**CITY OF DULUTH**

**STAFF REPORT**

| <b>File Number</b>          | PL 16-036                           | <b>Contact</b>                  | Jenn Reed Moses, jmoses@duluthmn.gov |
| <b>Location of Subject</b>  | 1734-1740 Mall Drive (Village Mall) |                                 |                                      |

| SHEET KEY      |                            |
|----------------|----------------------------|
| SHEET NUMBER   | L-1                        |

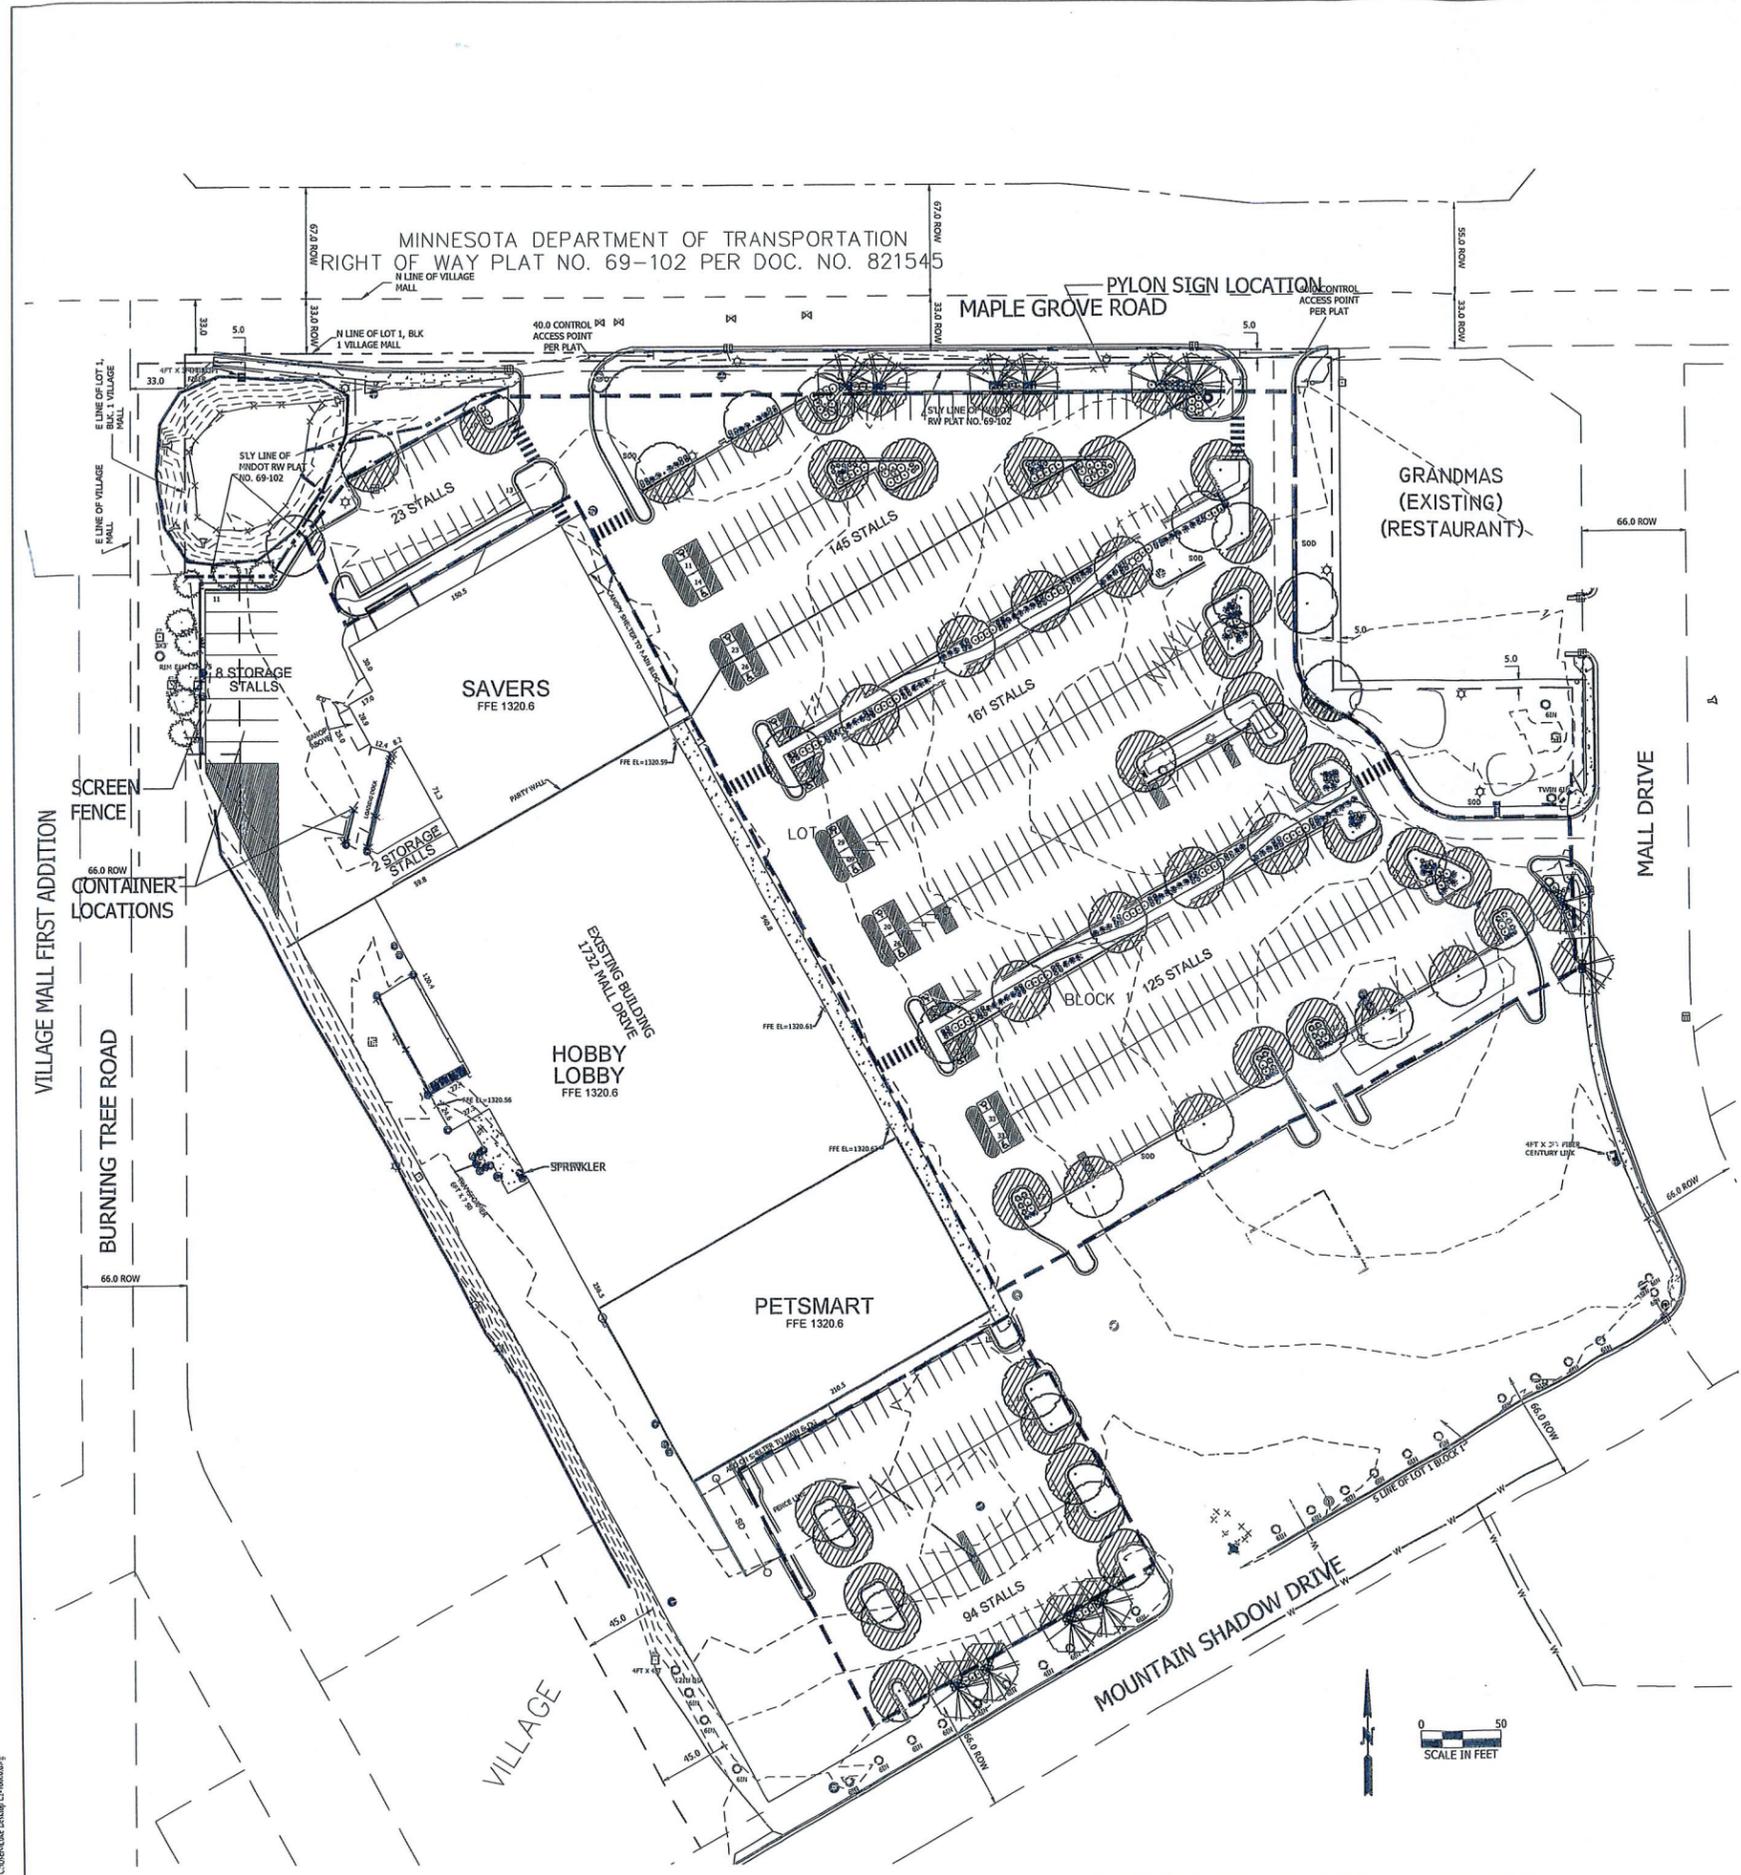
- 4.) 50-25 (Landscaping) - Applicant has requested an alternative landscaping plan in accordance with attached Landscaping Summary.
- 5.) 50-26 (Screening) - There are no changes proposed to existing loading docks and dumpsters. Applicant is proposing 8 "storage stalls" behind Savers; all storage trailers will use this space. New dumpsters for PetSmart will need to provide screening per UDC standards.

- 2.) Landscape Plan must comply with UDC standards, or receive approval of an Alternative Landscape Plan.
- 3.) Applicant sign an agreement agreeing to construct pedestrian connections between this site and a) future outlot/Aldi site when this is developed and b) Mountain Shadow Drive if and when a sidewalk is constructed in this location.

This project has requested approval of an Alternative Landscaping Plan that provides fewer trees on the site, in exchange for more shrubs and landscaped area, as well as stormwater benefits as mentioned below:
